UNITED STATES PATENT AND TRADEMARK OFFICE

Office Action Summary

This is the second office action for application number 09/629,241, Wiring Clip for Securing Electrical Wiring to a Framing Member, filed on July 31, 2000. Claims 1-16 are pending.

FURRING HANGER

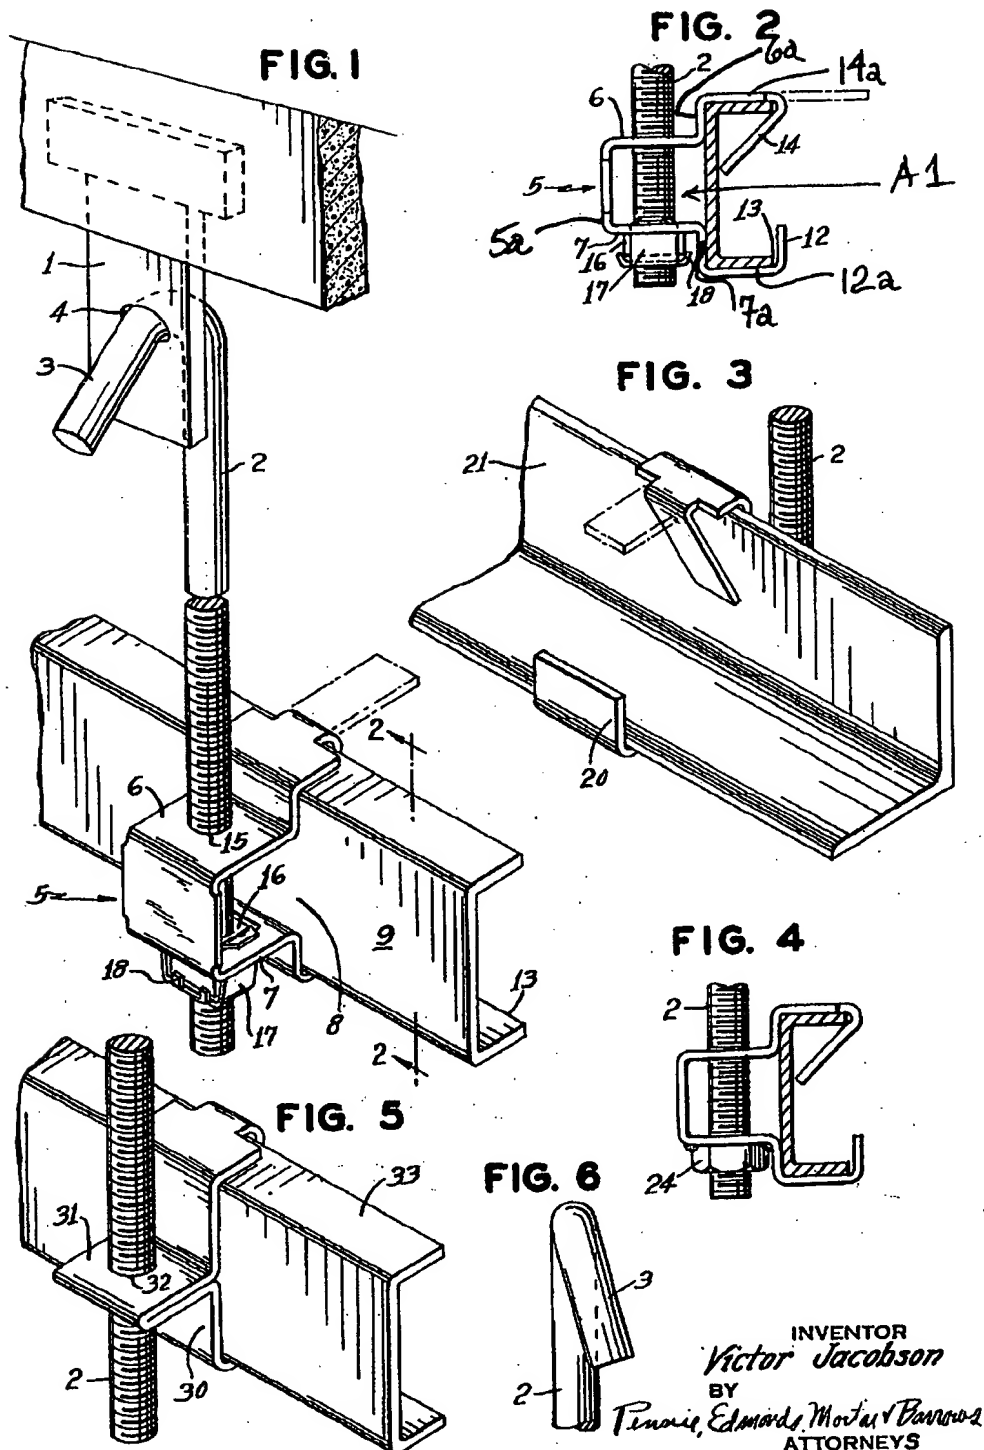
Claims 1, 5-10 and 12-13 are rejected under 35 U.S.C. 102(b) as being anticipated by U.S. Patent 2,631,809 to Jacobson. Jacobson discloses a wiring clip 5 (note attached marked-up copy of Figs. 1-2) including the following: a main body 5,5a,6,6a,7,7a; a wire receiving area A1 adjacent the main body; and, first and second arms 14a,12a each with respective first and second attachment means for attaching 14,12 located at first and second ends respectively. Jacobson also discloses that the first and second attachment means has a J-hook and a bend respectively. Finally, Jacobson disclose that the clip is dimensioned and made of thin metal or plastic for allowing a screw to penetrate the clip.

Regarding applicant's argument of Jacobson that "one skilled in the art... would need to thread wiring through hole 15", examiner respectfully disagrees. One skilled in the art would be able to locate wiring within A1 (see marked up copy attached) such that it extends longitudinally along the bar 9.
